Planning Commission
CITY HALL COUNCIL CHAMBERS **REVISED**
AGENDA OF JUNE 11, 2024
7:00 PM

1. PPZ2024-0257: Elite K911, 31740 Cook Rd, PPN 07-00-004-110-038
Applicant: Heller Carpentry and Handyman, LLC, 227 Main St, Apt. 327, Westlake, OH 44145. Owner: Chuck Stella, 31684 Cook Rd, North Ridgeville, OH 44039.

Proposal consists of constructing an addition to existing building for grooming facility. Property zoned B-3 Highway Commercial District.

NORTH RIDGEVILLE PLANNING COMMISSION
MINUTES OF REGULAR MEETING
WEDNESDAY, MAY 15, 2024

SHEET: C1.1

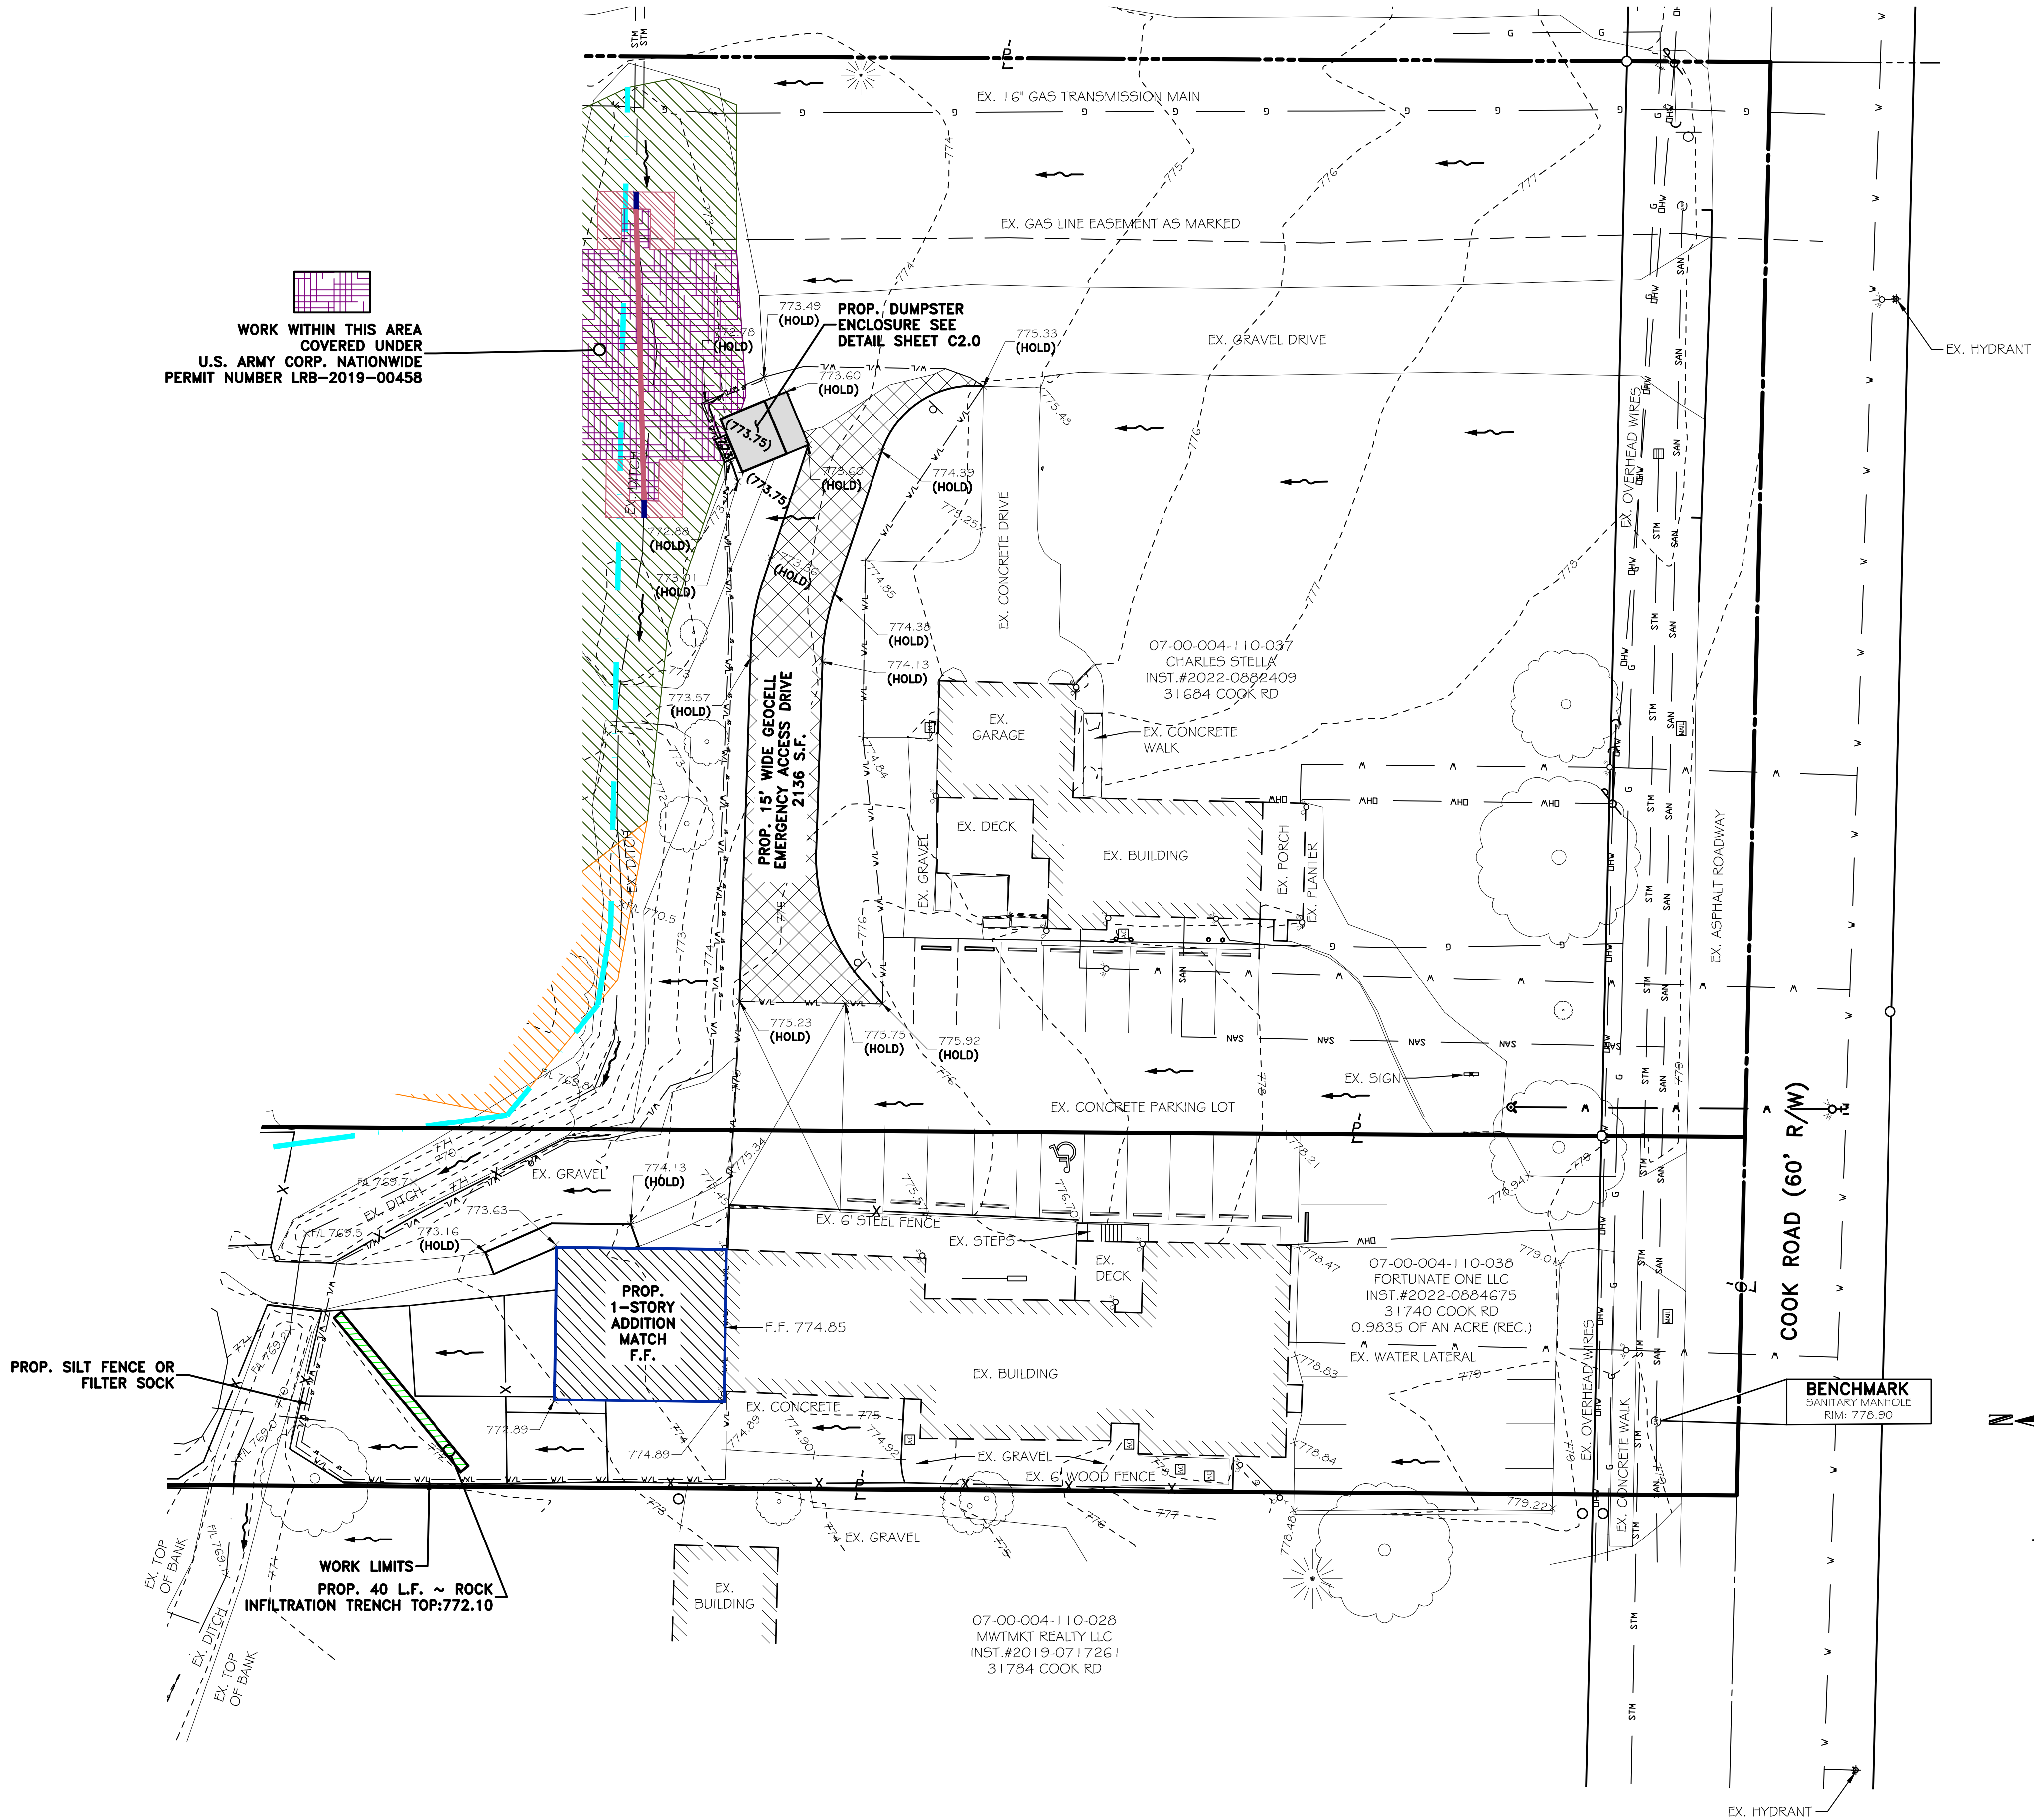
Site plans were revised and resubmitted to the City on May 22. Sheet C1.1 shows the 21-foot drive aisle with code complaint 18-foot-deep parking stalls. The plan notes Ex. Shed (Remove & Relocate). Plan is not clear if this is the current location or the proposed location? If current location, show where the shed is going to be moved to.

A-2

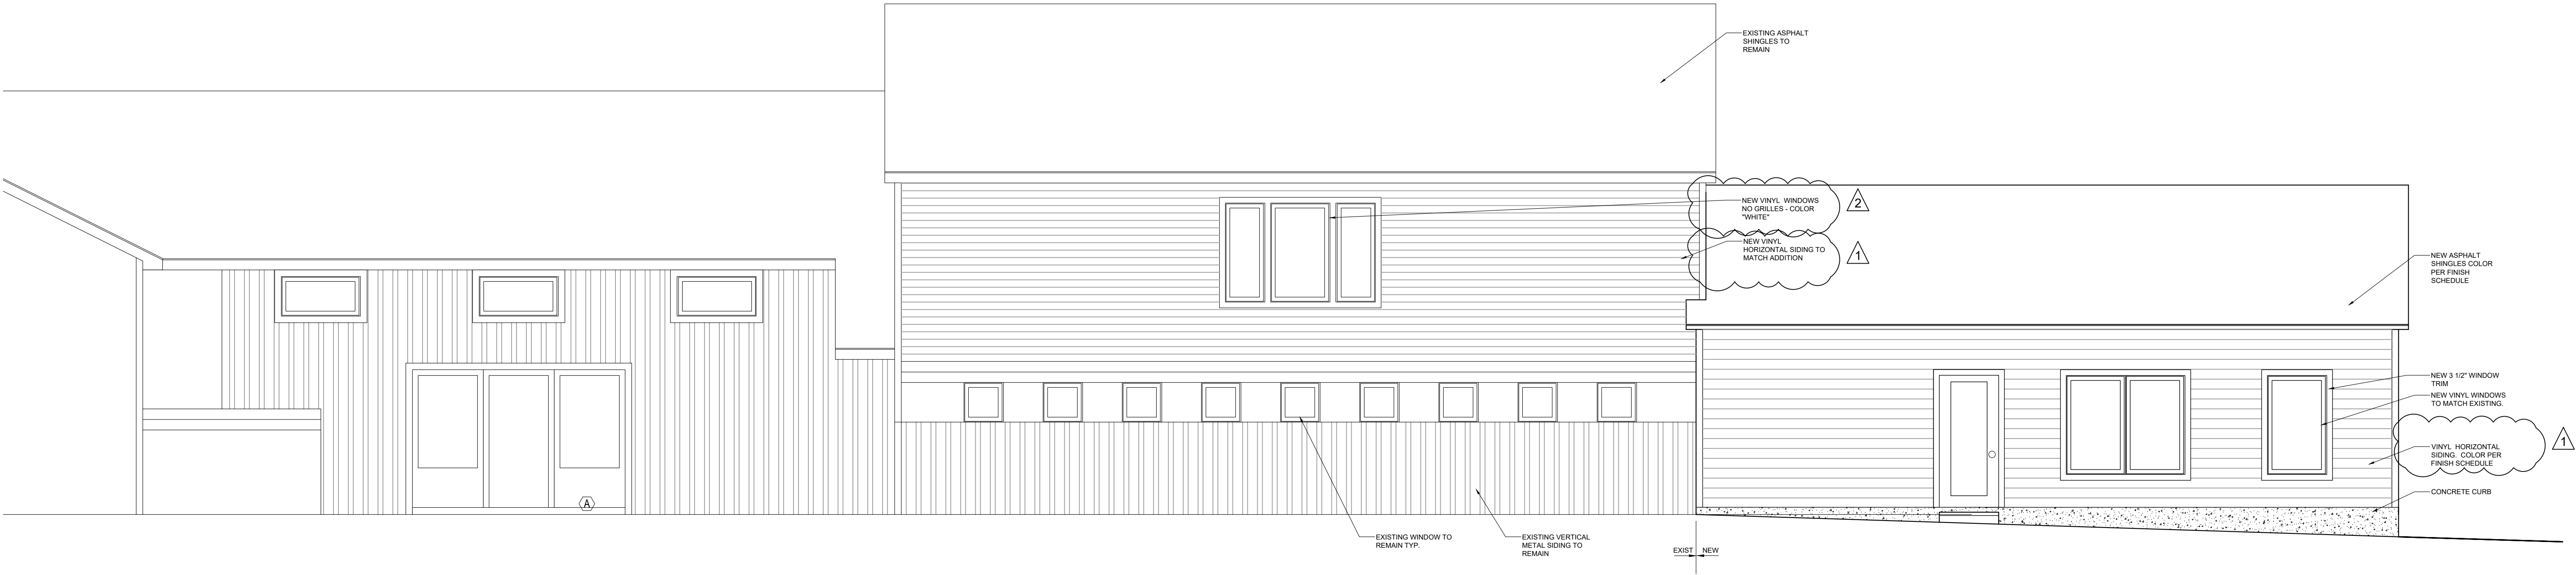
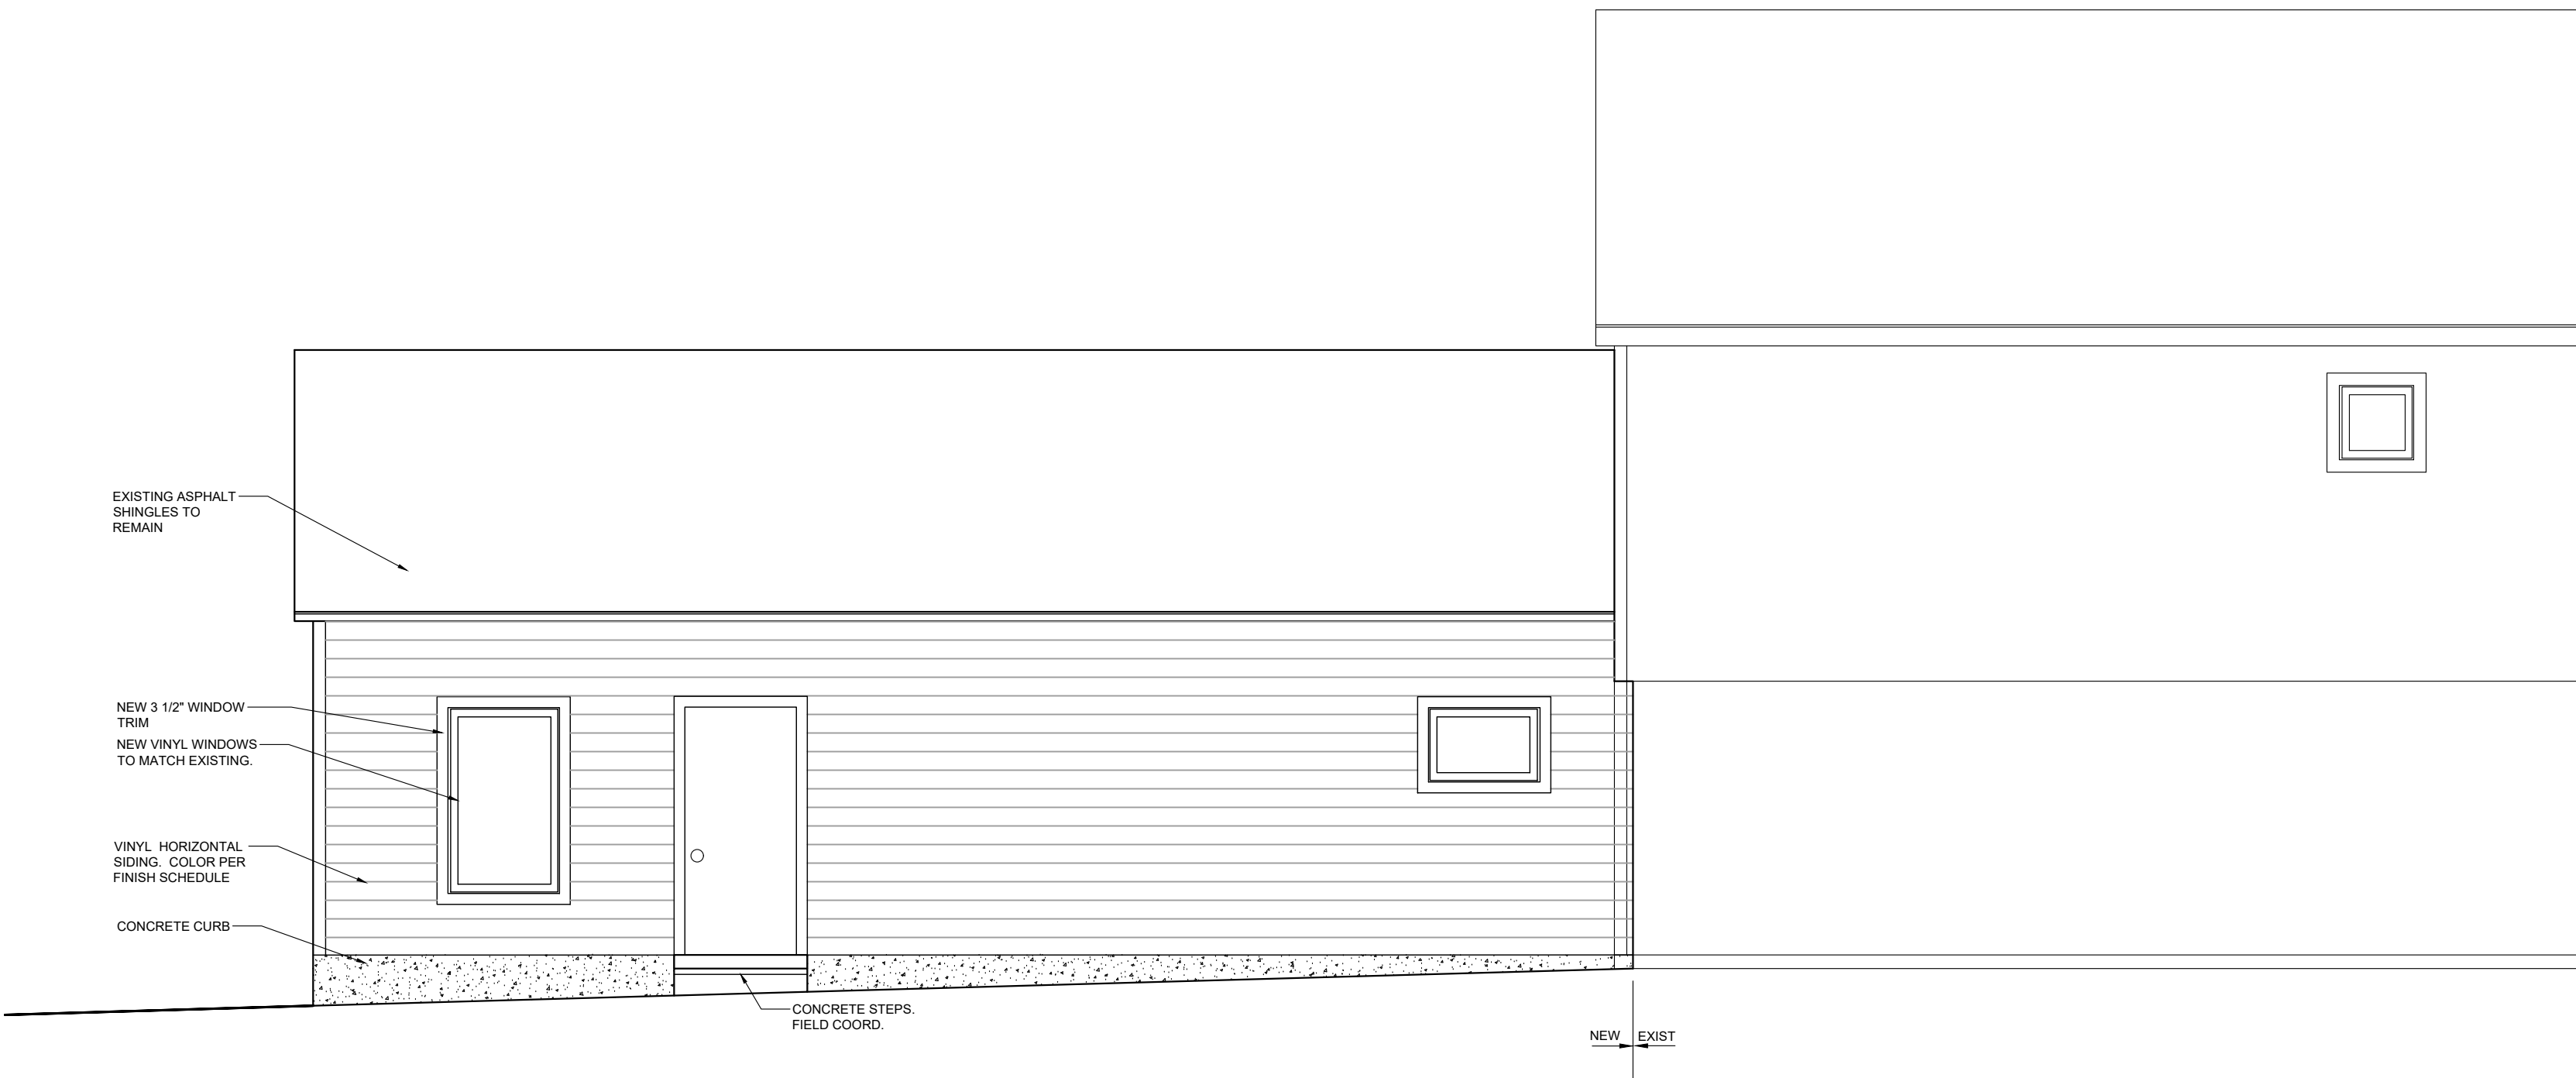
Director Lieber stated that he indicated that on the elevation that the new portion was to match the existing, then some of the siding was to remain and he was going to replace a window. She mentioned that they had asked for all those notes to be updated on that elevation, but they hadn't received anything back that showed all of what was to be updated, what would be new, what would match and what that would look like.

Building elevations were revised and resubmitted to the City on May 24. Sheet A-2 has been revised to incorporate all of the discussed building change and colors. No new building lighting is proposed.
